**ADDENDA  
ADDENDUM No. 1**

Date: January 15, 2019  
Project: OCHC Dental Renovation  
Project Number: 18-006  
Owner: Oneida Nation  
Architect: Oneida Engineering Department  
N7332 Water Circle Place  
Oneida, WI 54155  
To: Invited Bidders

This Addendum entails modifications to the existing NO and N20 lines as described in SK-1 and SK-2 dated January 15, 2019. This Addendum consist of 3 pages including this sheet and the following attachments:

**SK-1**  
 1/15/19

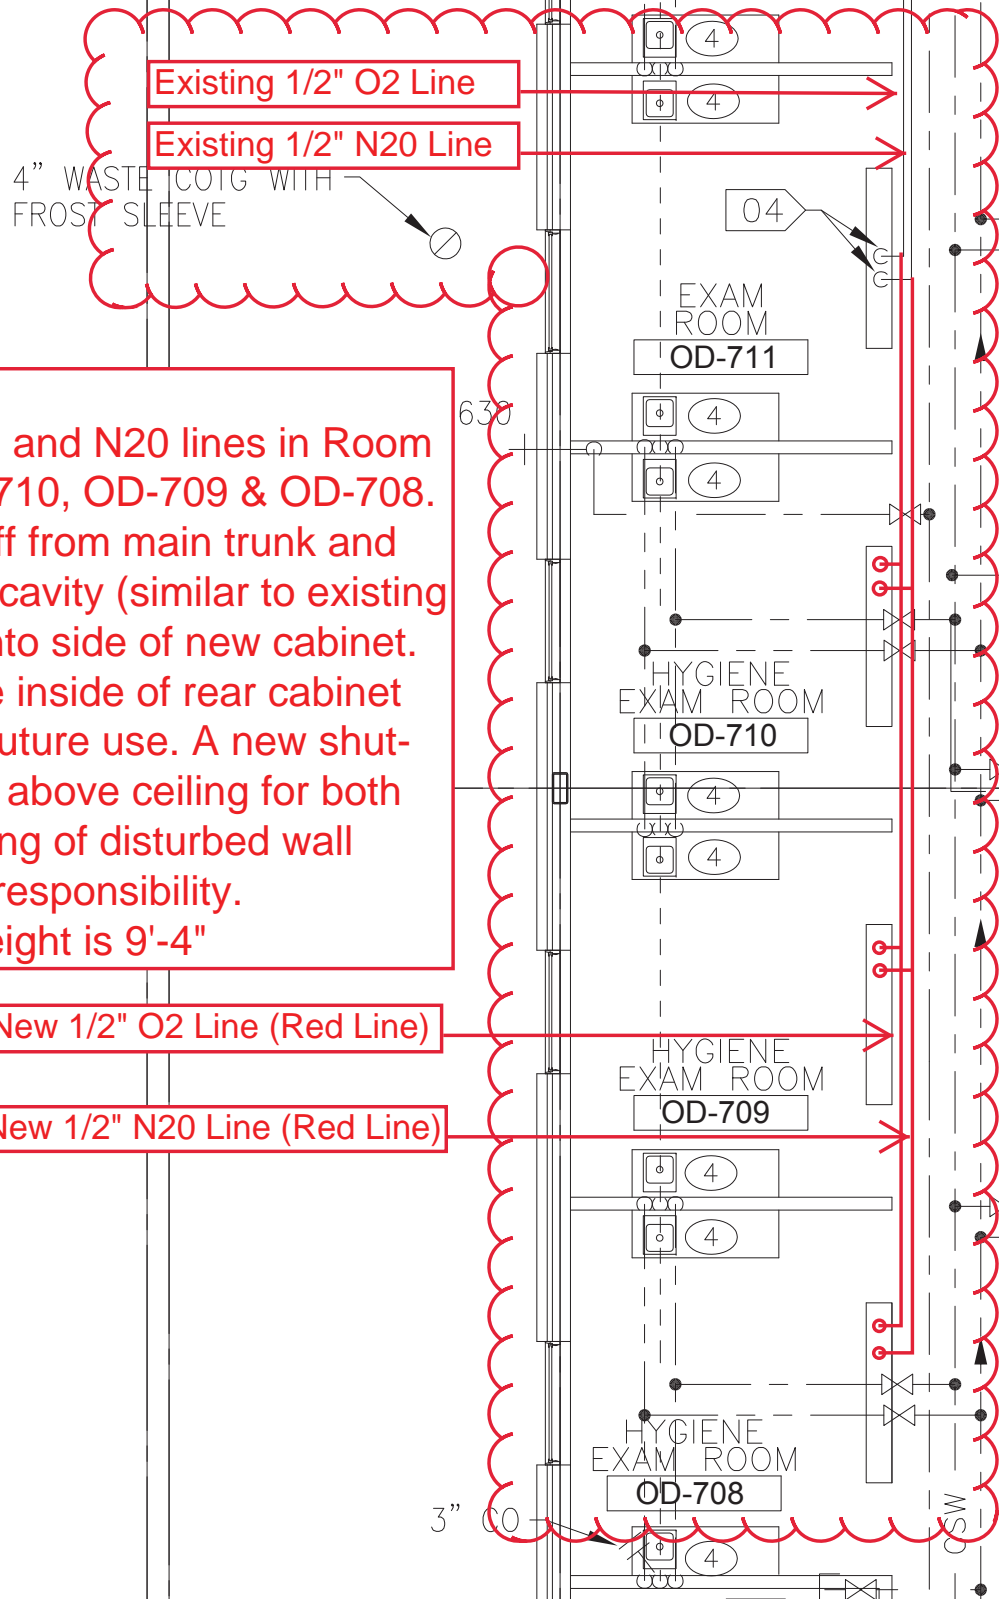
**Addendum #1:**  
 Extend existing 1/2" O2 and N20 lines in Room OD-711 to Rooms OD-710, OD-709 & OD-708. Both lines will branch off from main trunk and run down into rear wall cavity (similar to existing condition) then elbow into side of new cabinet. Both lines will terminate inside of rear cabinet and will be capped for future use. A new shut-off valve will be located above ceiling for both lines. Patching & finishing of disturbed wall surface is Contractor's responsibility.  
**Note:** Typical ceiling height is 9'-4"

New 1/2" O2 Line (Red Line)  
 New 1/2" N20 Line (Red Line)

Required for Rooms:  
OD-710, OD-709 & OD-708

Provide new shut-off  
valve for both lines  
above ceiling

New O2 and N2O  
lines

Terminate inside  
new rear cabinet  
and cap lines for  
future use
